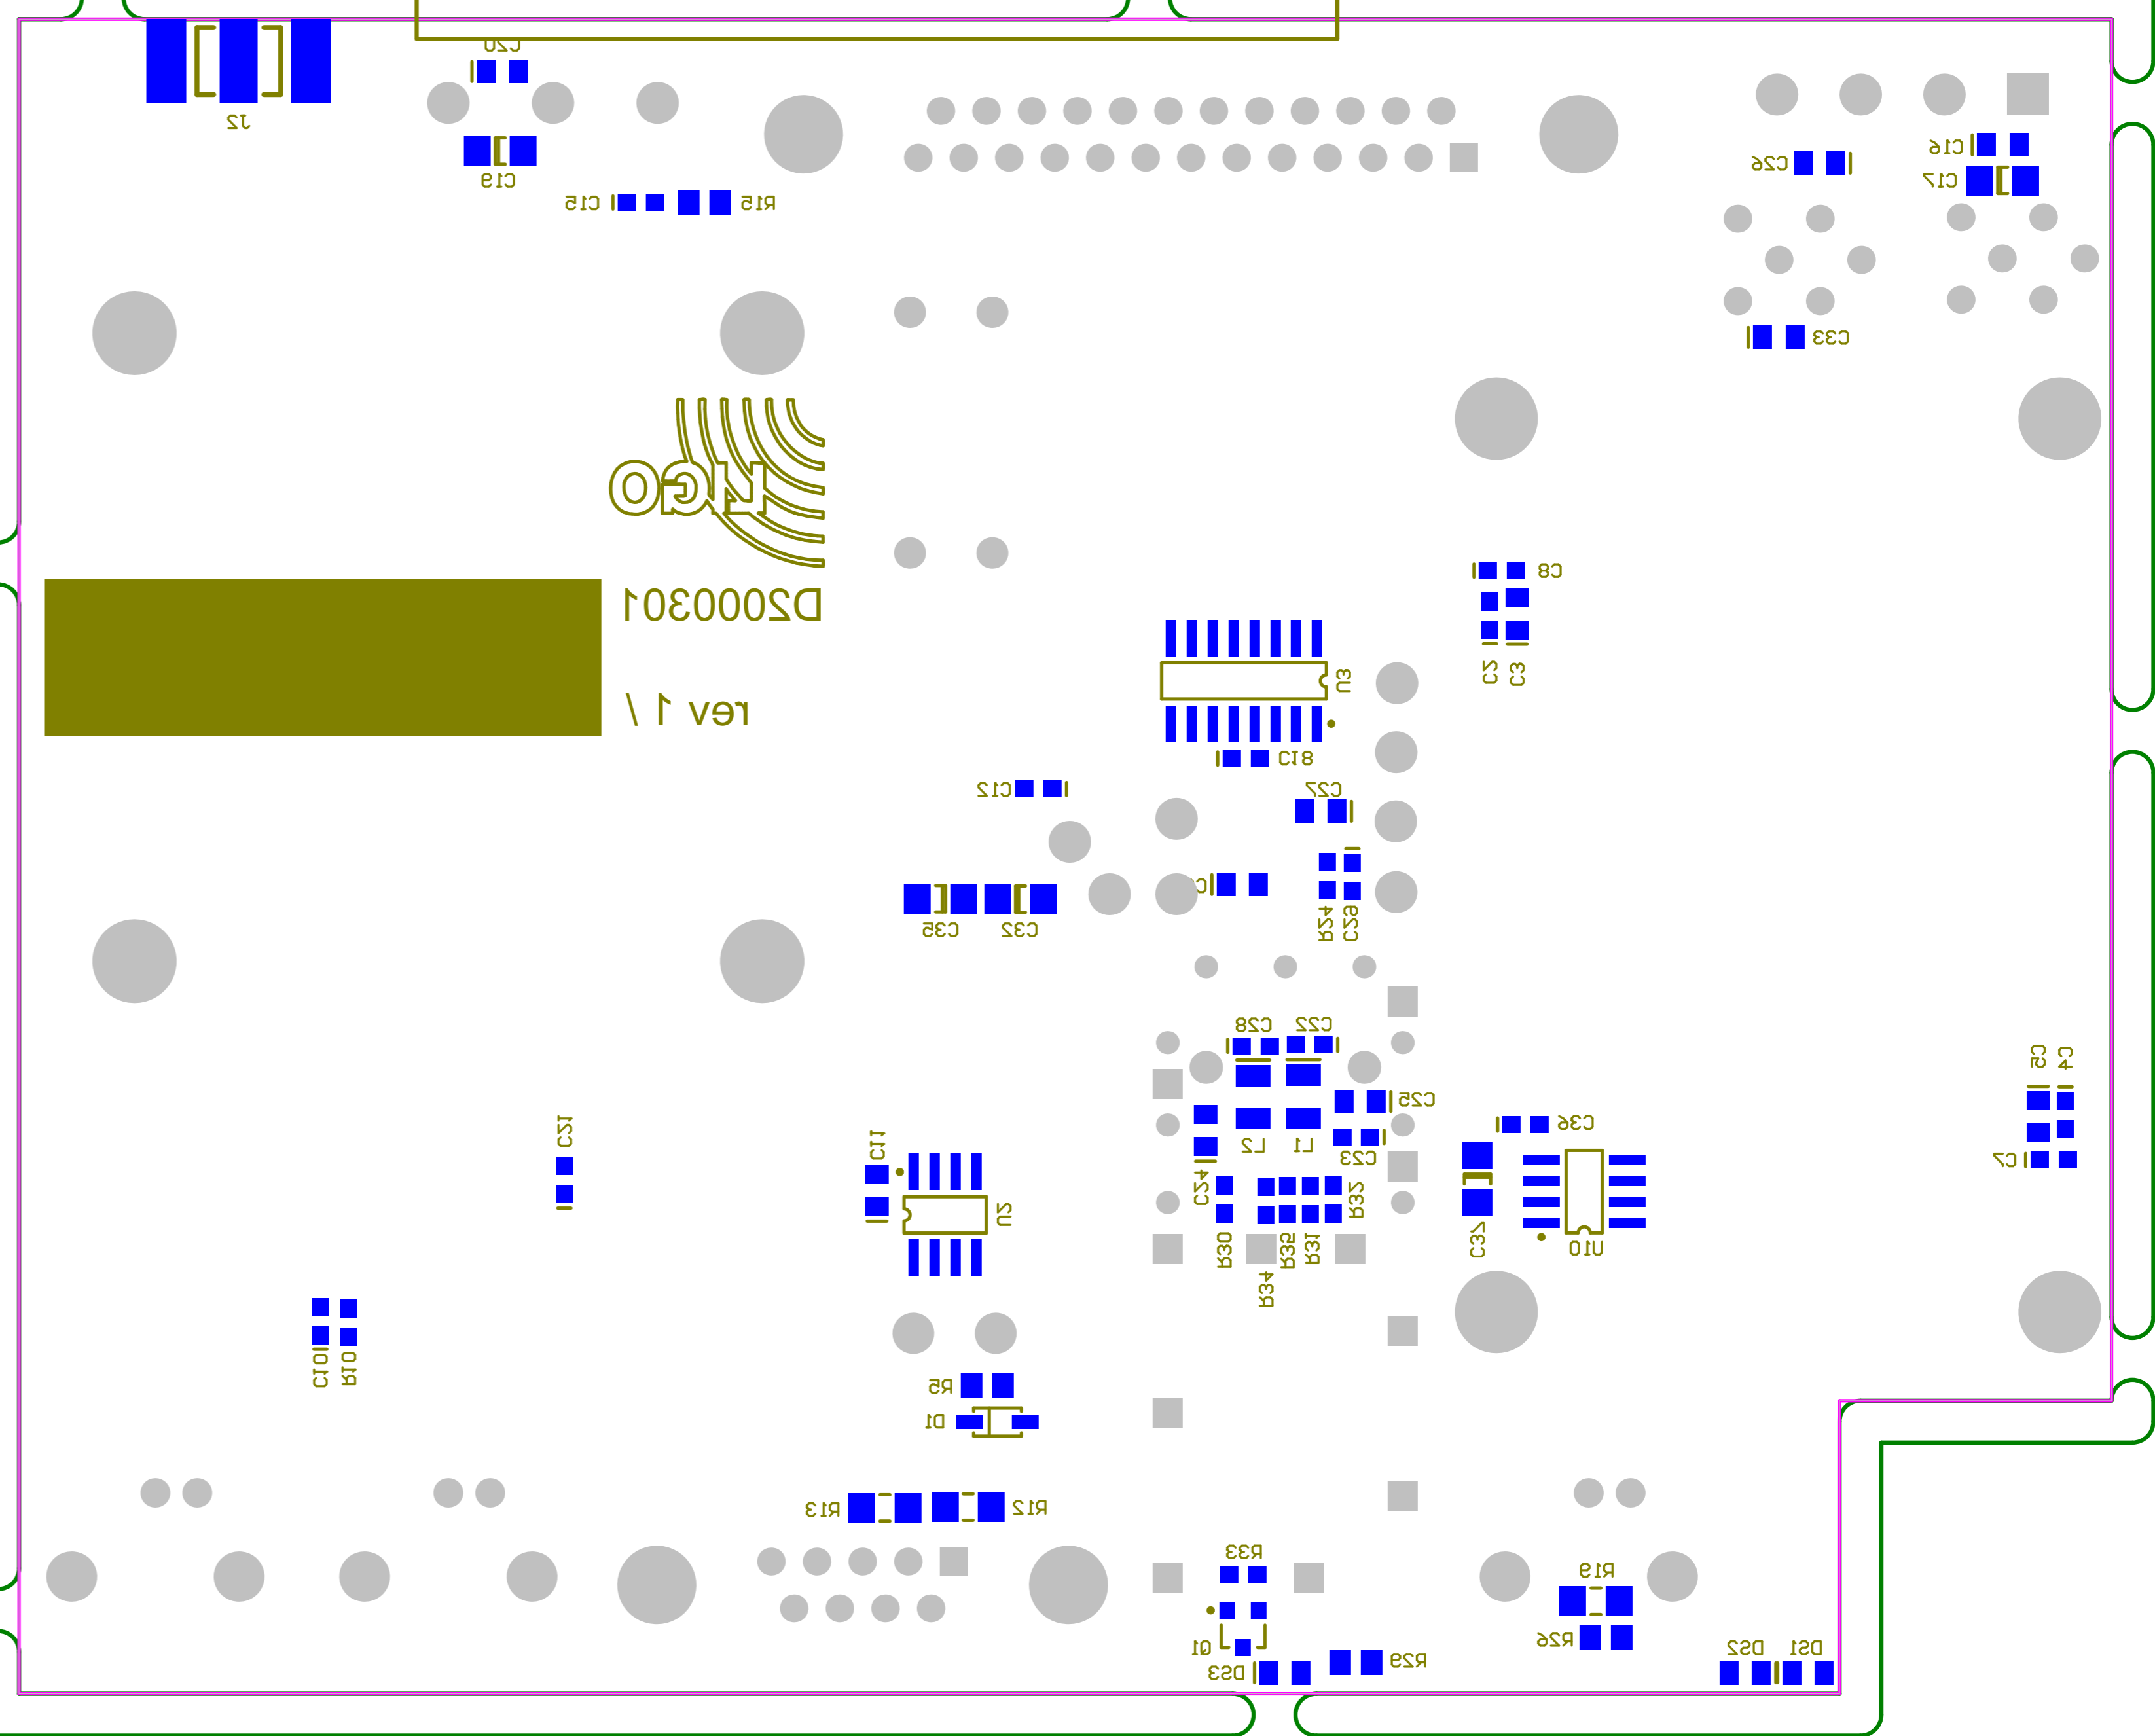
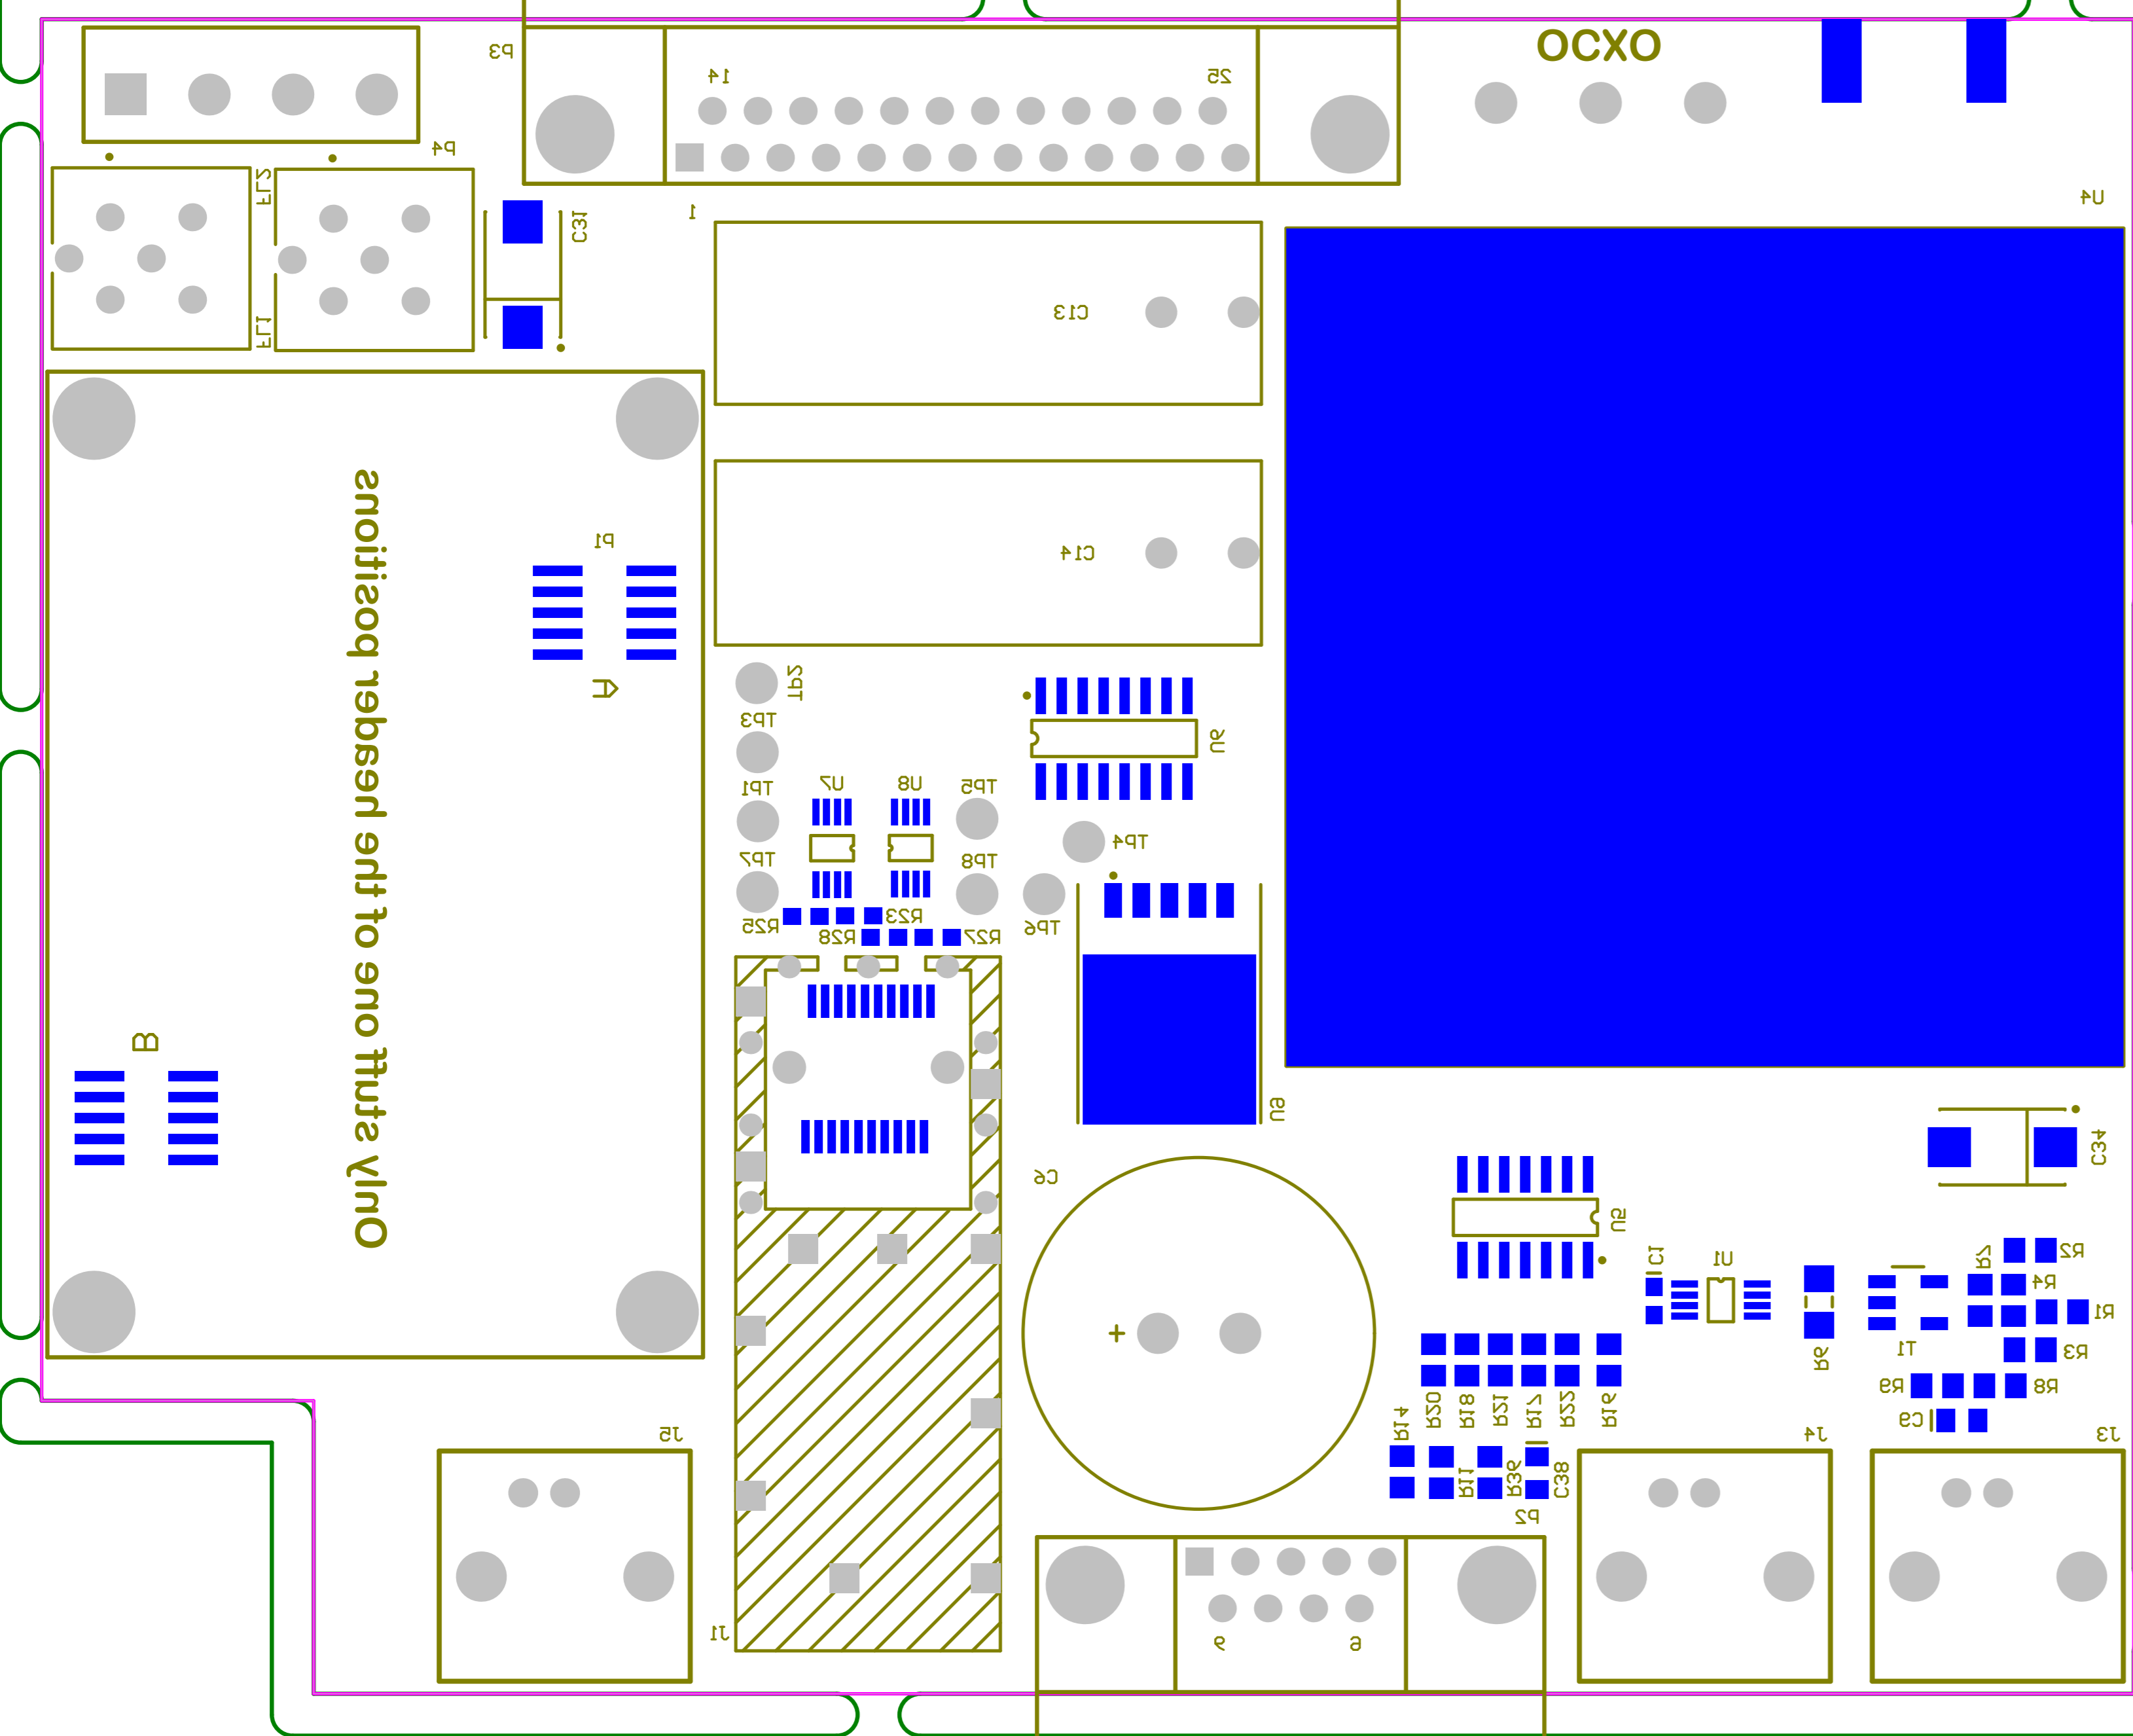
Only stuff one of the header positions

Only this one to be replaced
